Tonto Federal #3

Procedure for Recompletion to Lower Delaware and Bone Spring

Conditions of Approval

Shackelford Oil Company Tonto Federal - 03 API 3002534728

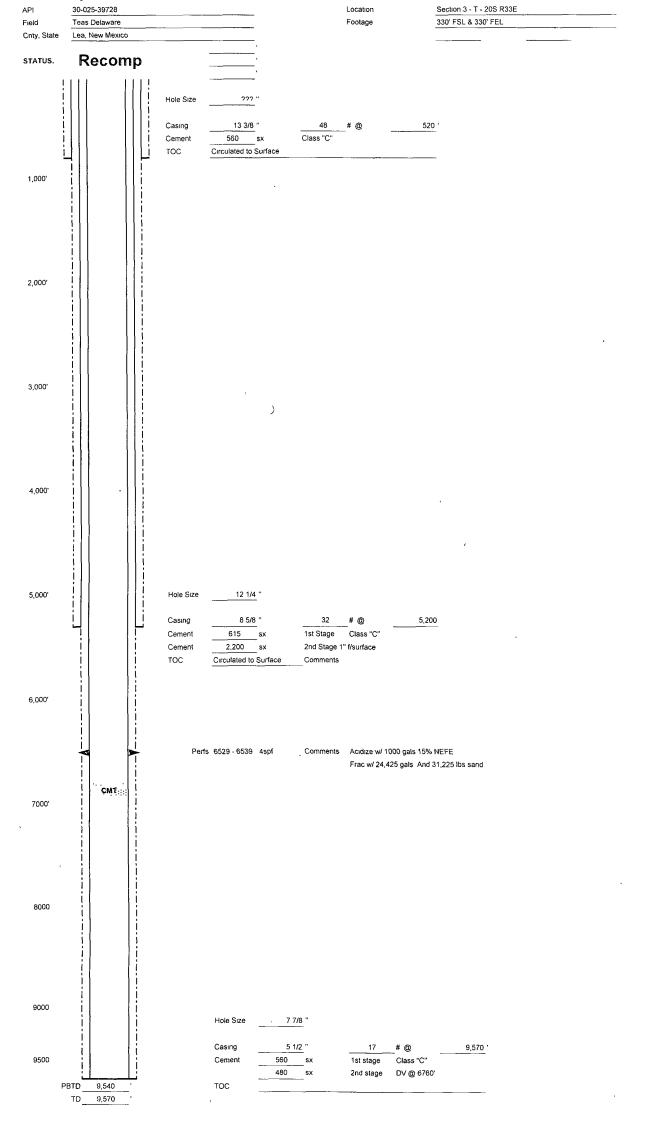
- 1. Notify BLM 575-361-2822 before squeezing the existing perforations. The squeezed perforations, DV tool and entire casing shall be pressure tested prior to perforating the Bone Spring formation. The pressure test shall be witnessed by a BLM PET and shall be for 30 minutes on a two hour chart. A 10% decrease in pressure will require remediation. Since there is no record of the Casing Integrity test for the production casing, the operator shall base the pressure requirement as per Onshore Order 2. Note the contact, time and date in your subsequent report.

- 8. Provide BLM with an electronic copy (Adobe Acrobat Document) cement bond log record from 9600' or below to top of cement. Less than 500' between the proposed top perforation and top of cement or lack of a 500' overlap above next casing shoe may require correction. The CFO BLM on call engineer may be reached at 575-706-2779.

- 10. File a **subsequent sundry** Form 3160-**5** within 30 days of the recompletion. Include an updated wellbore diagram. File the subsequent sundry for the fracture treatment separately if it is delayed as much as 20 days.
